Product Change Notification (PCN)

PCN Number	508223	Date Issued	May 19, 2020
Reason for Change	Change to Product		
Change Type Description	This letter is to inform you that changes are being made to the part(s) identified in this Notice. The change may affect the fit, form, function or appearance of the parts, or it may result in a change to the specification. The pictures below show an example of the possible differences.		
Assessment of Change	Product will be fully qualified before it is shipped. Qualification reports will be available after below listed date		
Internal Molex Qualification Date	February 03, 2020		
Sample Availability Date (Changed Part)	February 03, 2020		
Planned Implementation Date	November 19, 2020		
Method of Identifying Change	Date code

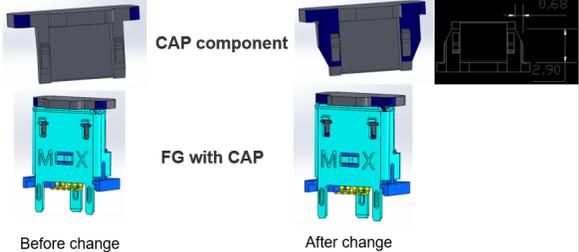
- Micro USB 105133 series HSG Cover design change to improve the cap retention force and offset risk.
- Cover sides fork lock expand to 0.68mm, length 2.90mm

- Overview**
- 1. Change reason: increase the cover retention force for internal continuous improvement
 - 2. Product Impact
 - No impact to fit, form and function
 - 3. Part Number Impact
 - see attached part list
 - 4. Qualification Reports and samples available upon request after the running change date
